SERVICE BULLETIN
Roms and Rams Self Testing

MIDWAY MFG. CO.

S E R V I C E B U L L E T I N

ANTI-PENNY DEVICE INSTALLATION

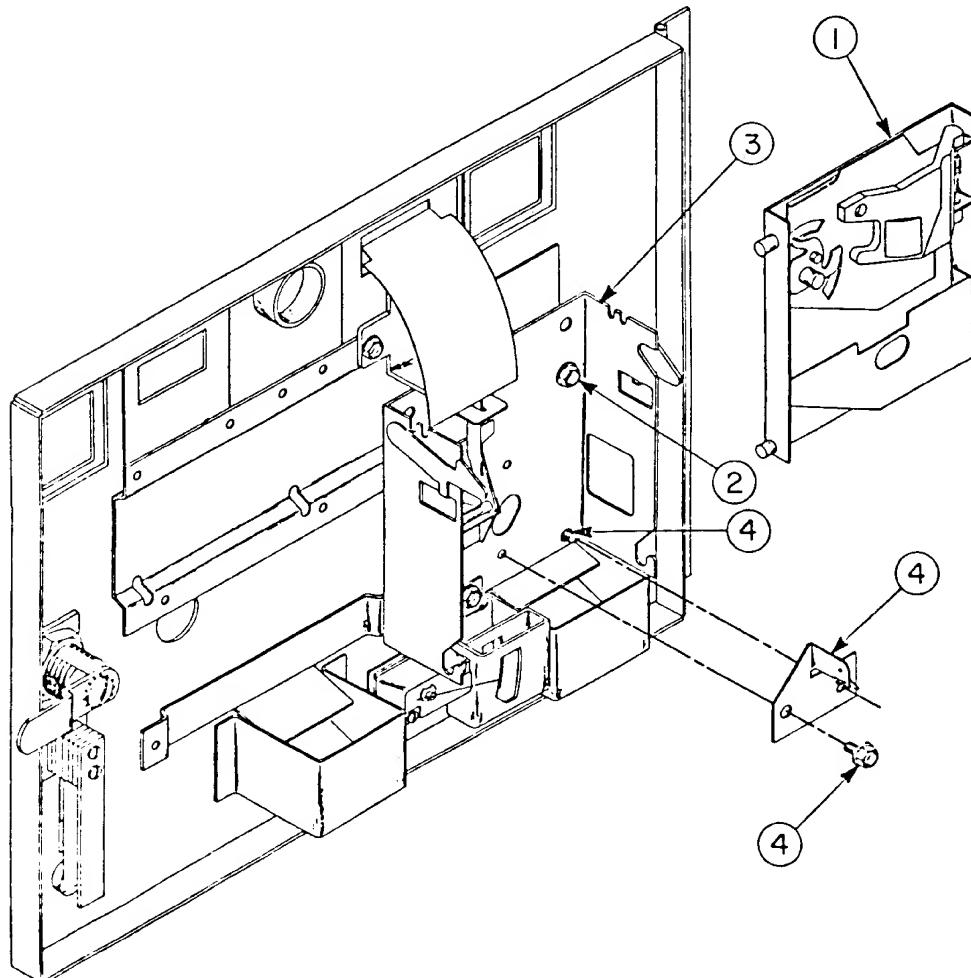
1. REMOVE COIN ACCEPTOR FROM BRACKET.
2. REMOVE (3) HEX HEAD SCREWS THAT HOLD BRACKET TO DOOR.
3. REMOVE BRACKET FROM DOOR.
4. INSTALL ANTI-PENNY DEVICE MIDWAY PART NO. A090-00064-0000 USING (2) 6-32 x 5/16 SLOT HEX HEAD SCREWS MIDWAY PART NO. 0017-00101-0555. MOUNT DEVICE WITH 1 SCREW FROM THE FRONT AND 1 SCREW FROM THE BACK OF BRACKET AS SHOWN.
5. SCREW BRACKET BACK TO DOOR AND SNAP COIN ACCEPTOR BACK IN PLACE.

ANTI-CHEAT COIN CHUTE REWORK

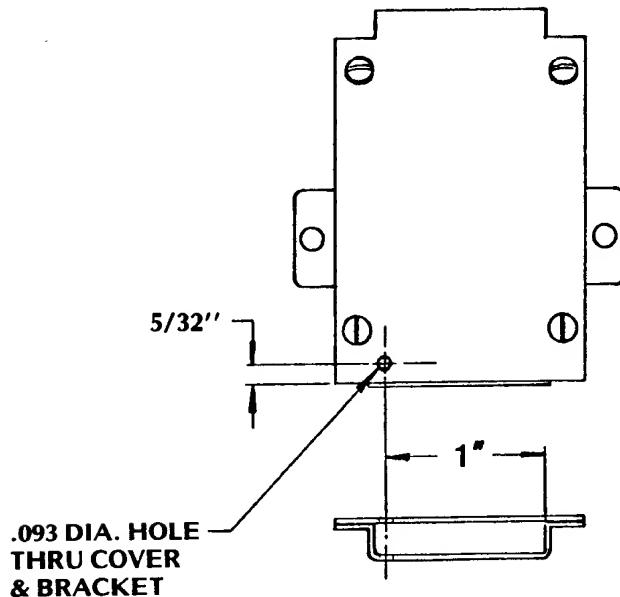
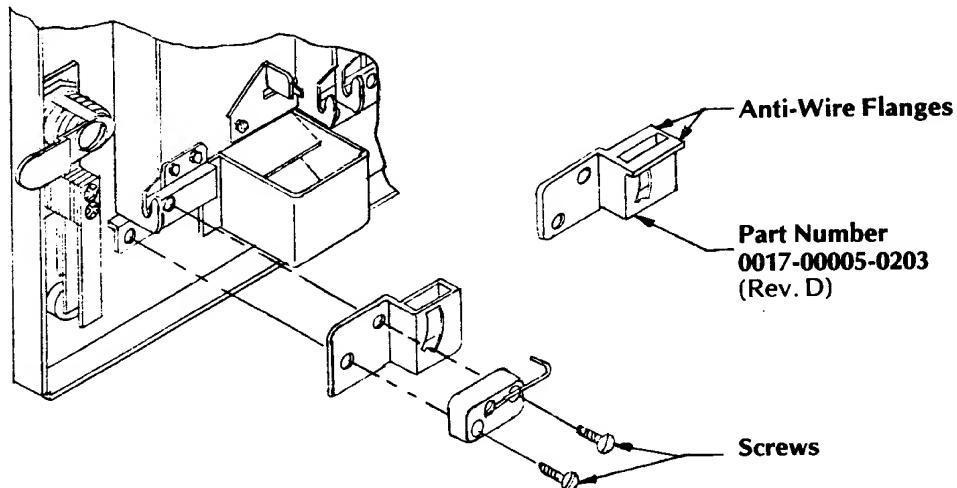
1. DRILL .093 DIA. HOLE THRU COVER AND BRACKET AS SHOWN.
2. REMOVE BURRS FROM EDGES OF HOLE AFTER DRILLING.
3. INSERT 1/16" DIA. COTTER PIN.
4. PIN MUST MOVE FREELY.
5. OBJECT IS TO KICK PENNY TO THE RIGHT AND SLOW IT DOWN.
6. MAKE SURE QUARTER WILL PASS THROUGH AFTER COTTER PIN IS INSERTED.

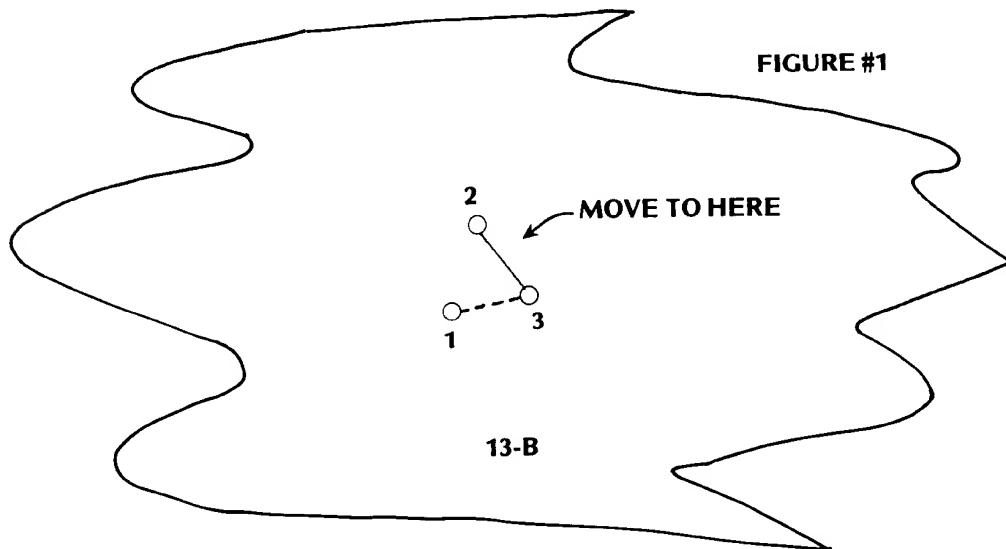
GAME: LAZARIAN (SERIAL NO. 101 to 500).

SUBJECT: LOCK UP CONDITION ON POWER OFF & ON

1. Enable the watchdog circuit by moving the jumper wire near location 13-B from position 1 & 3 to position 2 & 3. (See Figure #1).

FIGURE #1

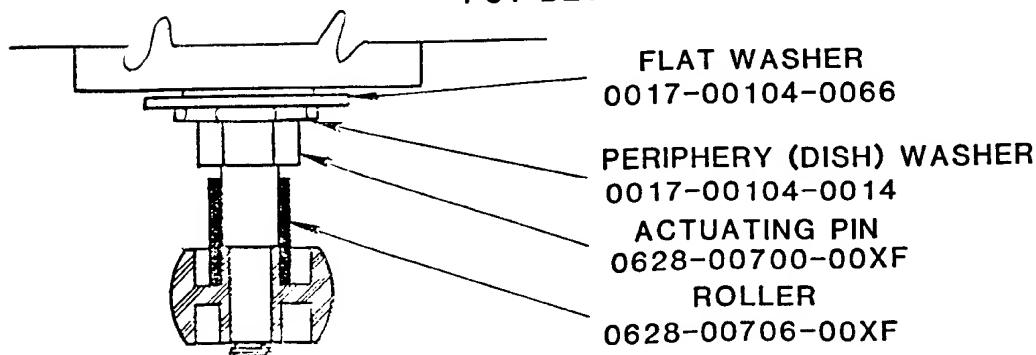
GAME: TRON (SERIAL NUMBER 101-1200)

SUBJECT: CONTROL ASSEMBLY

CONDITION: LOOSE ACTUATING PIN

1. Add a flat washer, a periphery washer and a roller as shown in Figure #1.
2. Check out mechanically.

1. TORQUE ACTUATING PIN TO 75 in/lbs \pm 10%
IT IS SUGGESTED TO USE A LOCTITE COMPOUND.
2. A LIGHT GREASE (0017-00008-0087) MUST BE
PUT BETWEEN THE ACTUATING PIN & ROLLER

Figure #1

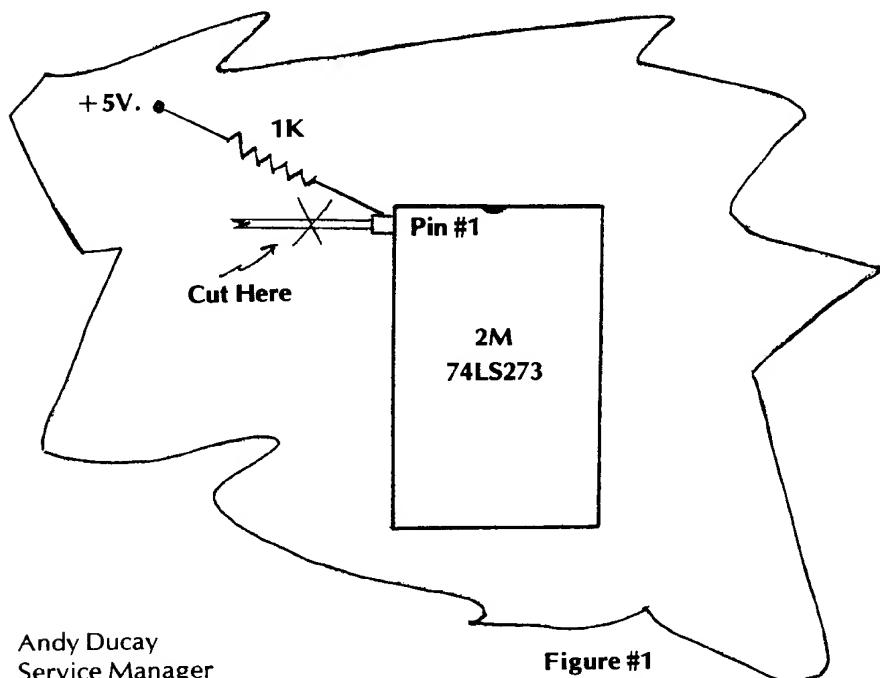
GAME: PAC-MAN & MS. PAC-MAN

SUBJECT: INTERMITTENT LOSS OF SOUND (STATIC)

1. Cut trace to pin #1 of 2M (74LS273).
2. Solder 1K resistor from +5VDC to pin #1 of IC 2M. (See Figure #1).

SUBJECT: Angle Encoders

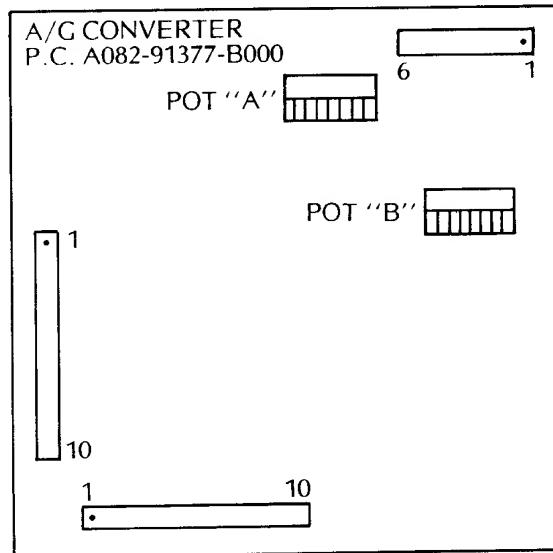
1. Due to a shortage of Encoders some games will have 25K pots. (two)
2. For proper operation of pots a A/G converter. PC A082-91377-B000 has been added.
3. The A/G Converter PC is mounted under the control panel.
4. Refer to instruction adjustment for proper pot alignment.

FIGURE #1

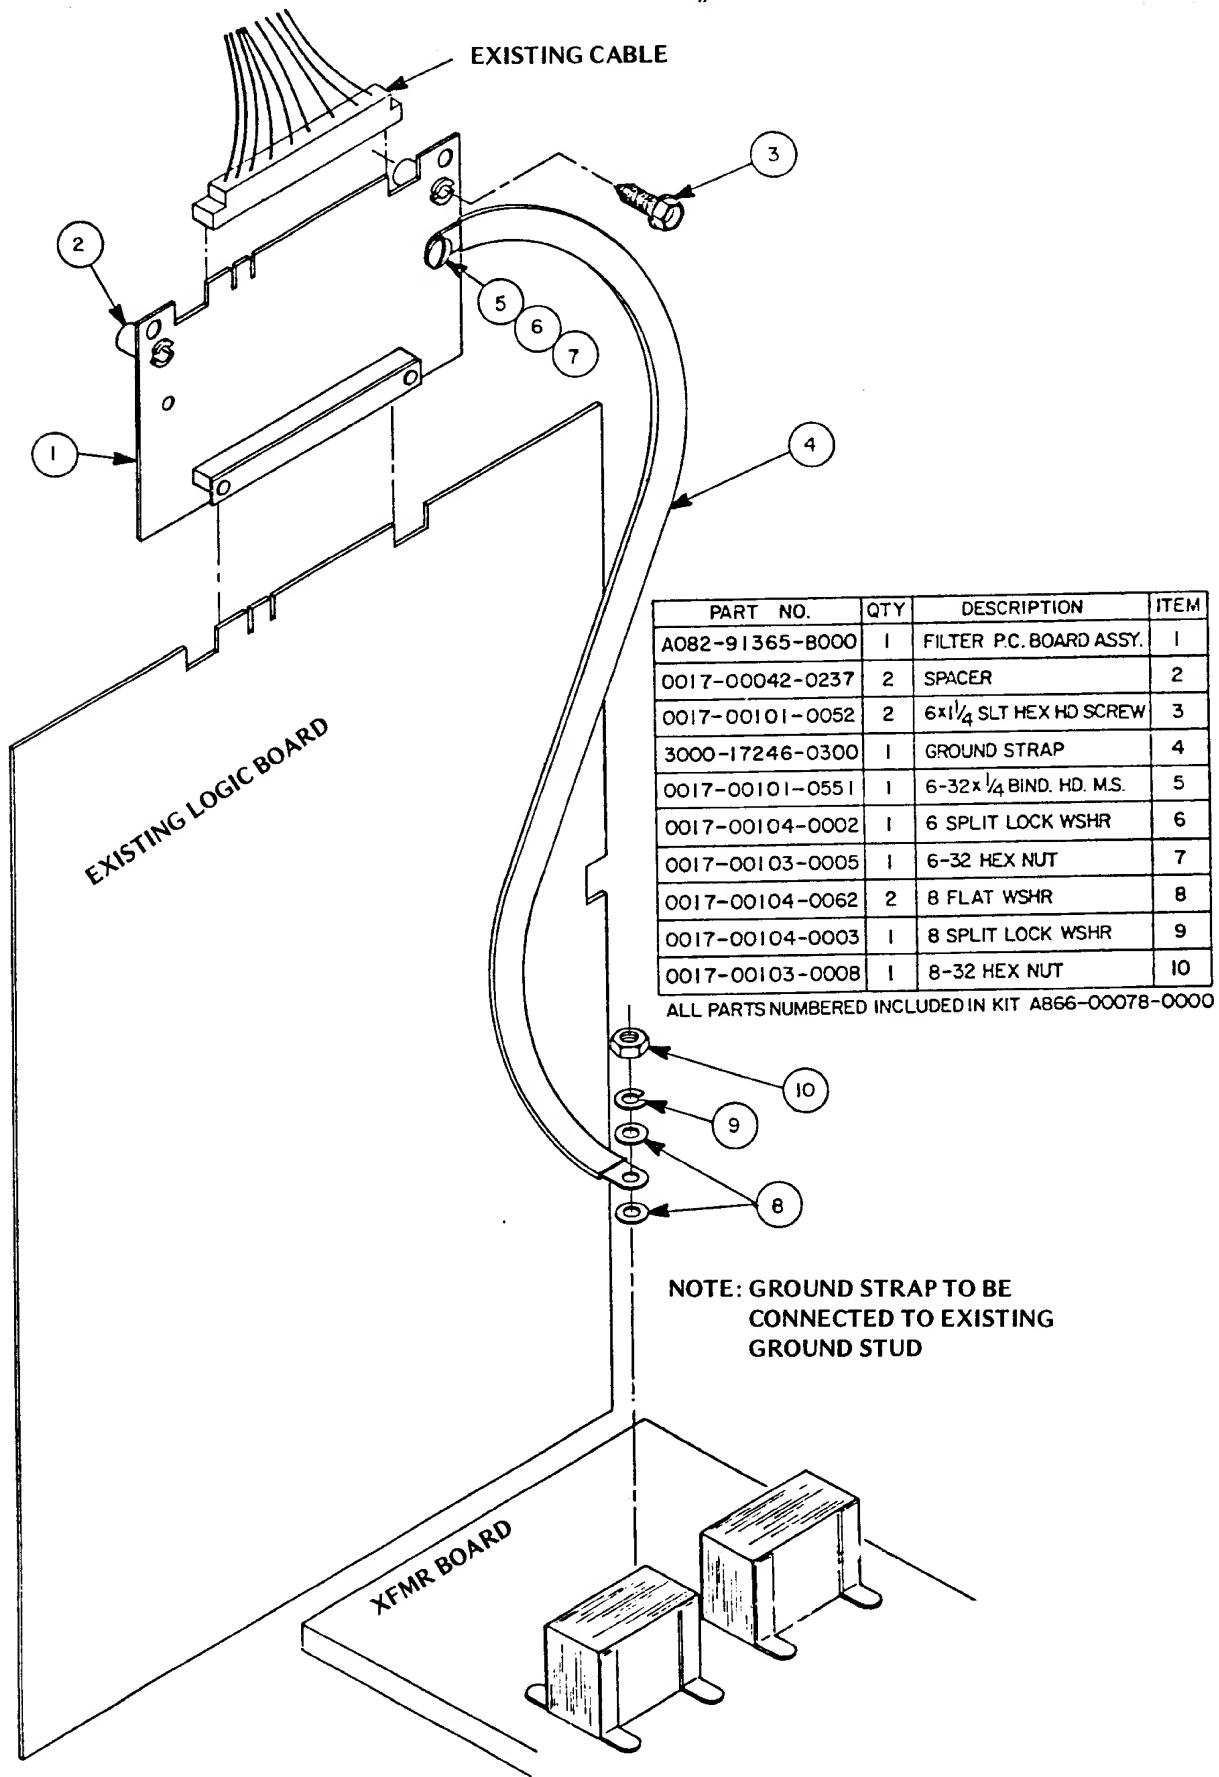
ANTI-STATIC INSTALLATION INSTRUCTIONS FOR GALAXIAN

FIGURE 1

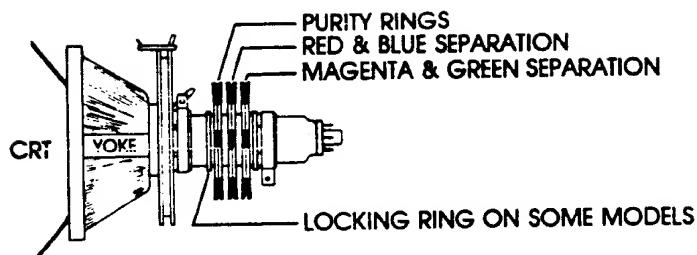
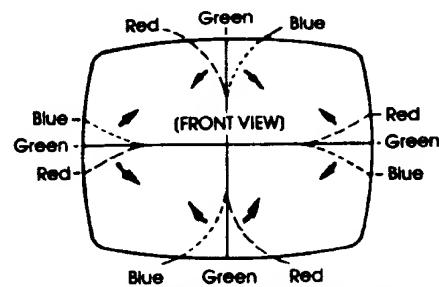
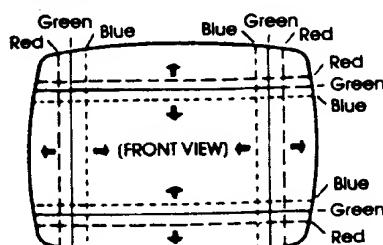
- A. Tilt the yoke up, down, left and right to achieve convergence around the edges. Secure with one temporary wedge.
- B. Rotate the center rings to adjust the red and blue separation.
- C. Rotate the rear rings to adjust the magenta (red-blue) and green separation; when best results are obtained, seal the rings with nail polish.
- D. Remove the temporary wedge from the yoke. Tilt the yoke again to adjust the edges of the screen for minimum separation and insert three new wedges. These should have adhesive added to hold them permanently.

Let the red and blue lines come in line by turning two 4-pole magnets.

Let the green and magenta lines come in line by turning two 6-pole magnets.

Figure #1

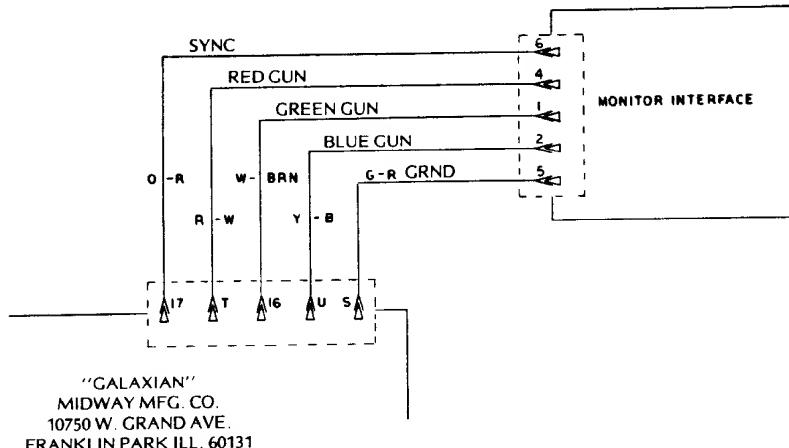
1. Proper video cable wire sequence for interface PC, Wells Gardner color monitor 19K4500. (See Figure #1)

Figure #2

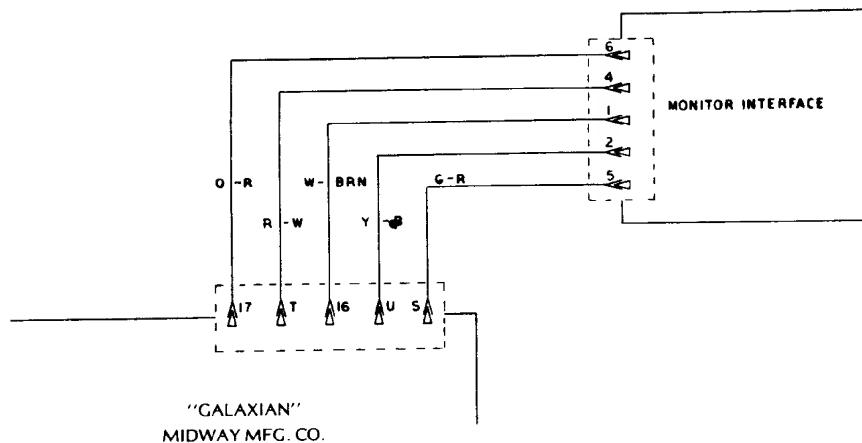
2. Proper video cable wire sequence for interface PC, Wells Gardner color monitor 19K4601. (Upright) (See Figure #2).

Figure #3

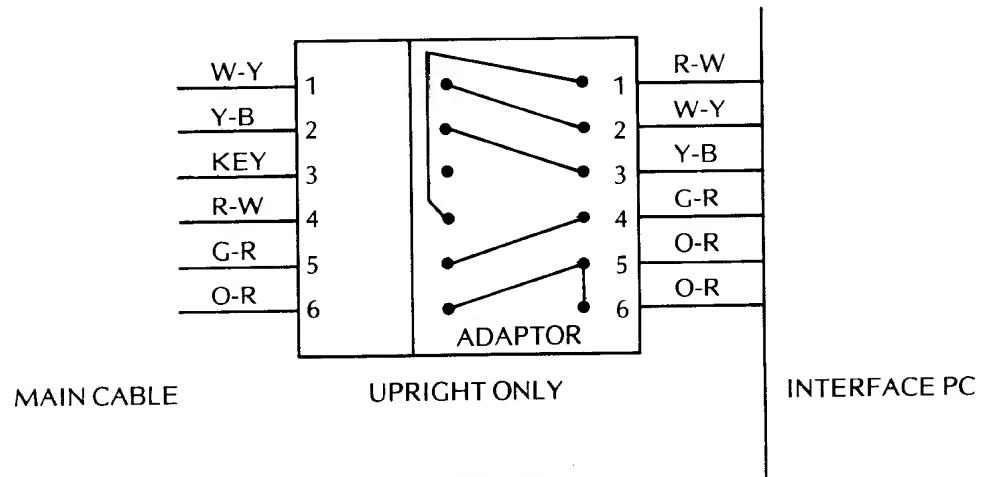
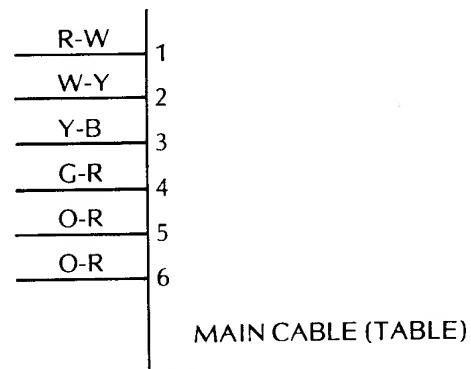
3. Proper video cable wire sequence for interface PC, Electrohome 19" color monitor G07 - 901 & 905 (upright & cocktail table). (See Figure #3)

- NOTE: 1. The adaptor Jack PC A080 - 91106 is used in upright games for proper wire sequence.
2. The cocktail table wire sequence if for the Electrohome Monitor.

Figure #4

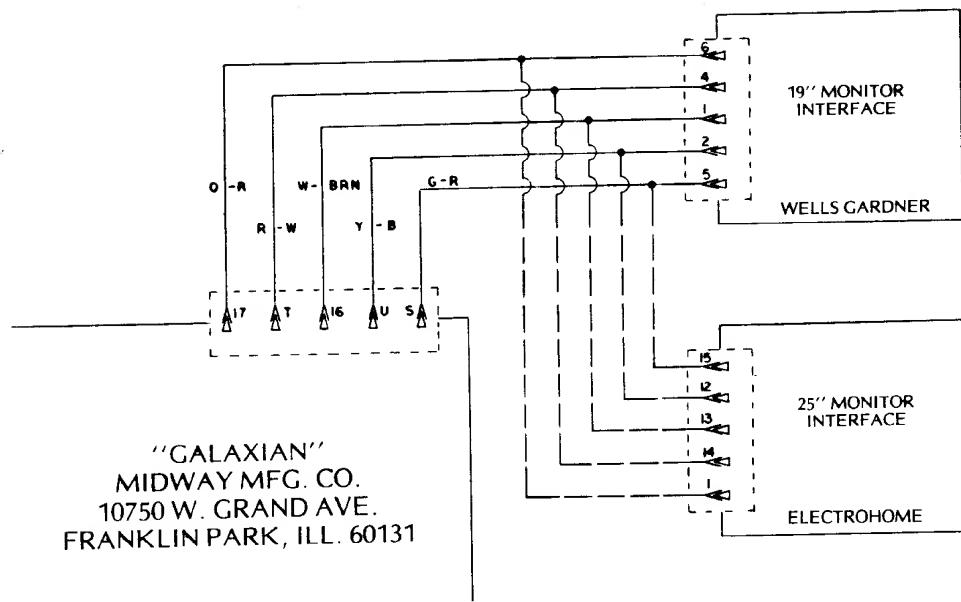
4. Proper video cable wire sequence for interface PC, Electrohome color monitor. G02- 25 inch (upright). (See Figure #4)

NOTE: Due to cable changes and other modifications the 25 inch color monitor must be used.

Figure #5

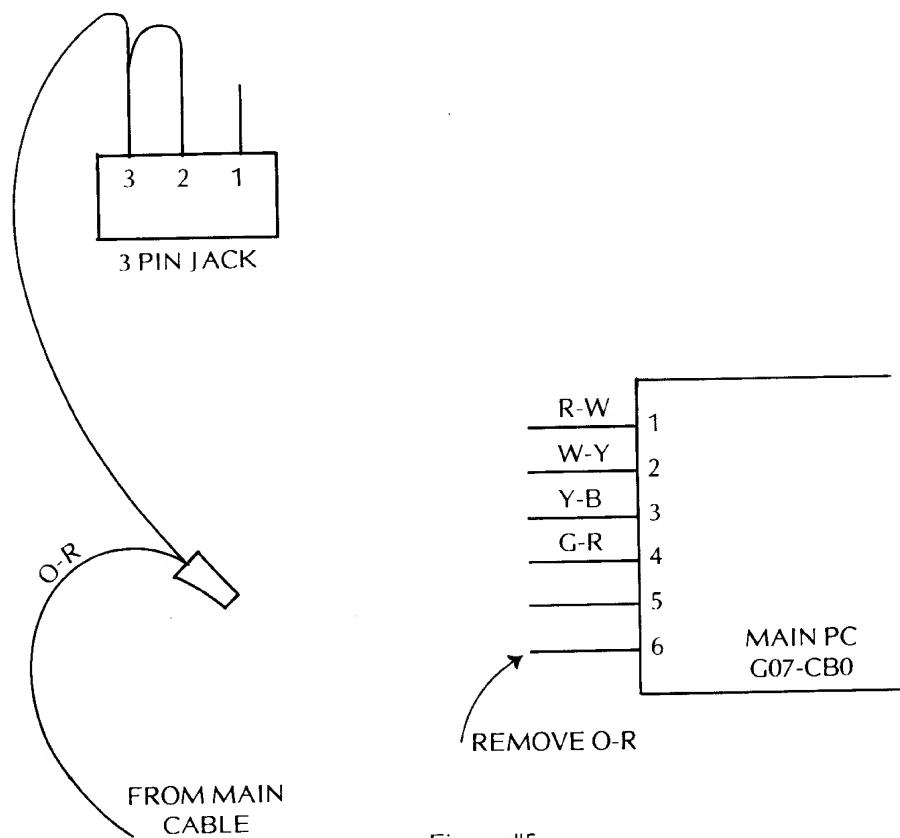
5. Proper video cable wire sequence for interface PC, Electrohome color monitor G07 CB0 - 904. (upright & cocktail table). (See Figure #5)

- NOTE:
1. The adaptor jack PCA080 - 91106 is used to eliminate wire changes in upright games.
 2. Not used in cocktail table games. (PCA080 - 91106).
 3. The orange - red must go to 3 pin jack as shown.

FIGURE #1

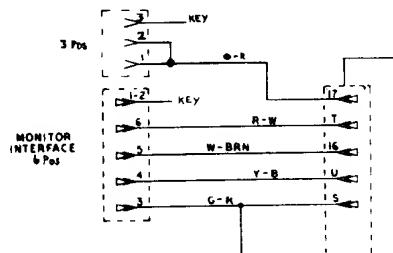
1. PROPER VIDEO CABLE WIRE SEQUENCE FOR WELLS GARDNER COLOR MONITOR 19K4606

FIGURE #1

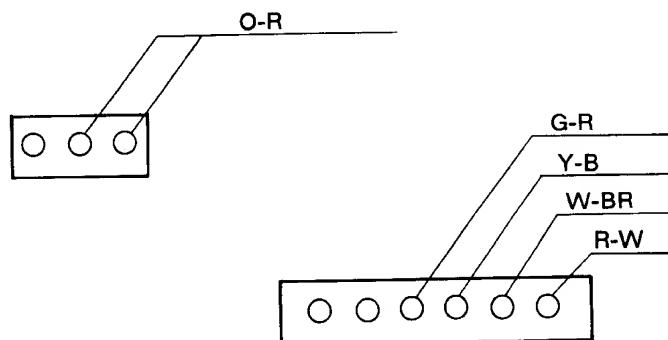
1. PROPER VIDEO CABLE WIRE SEQUENCE FOR ELECTROHOME 19''
COLOR MONITOR G07-CB0

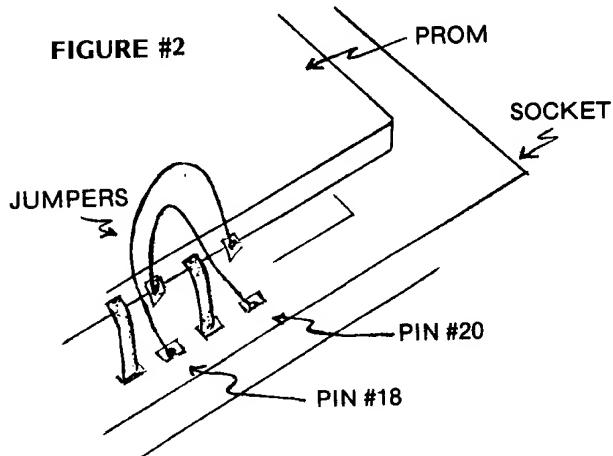
1. Refer to figure #1 for proper strapping of jumpers and capacitor removing or relocating.
2. Cut pins #18 and #20 of each prom and jumper as shown in figure #2.
3. Check electrically.
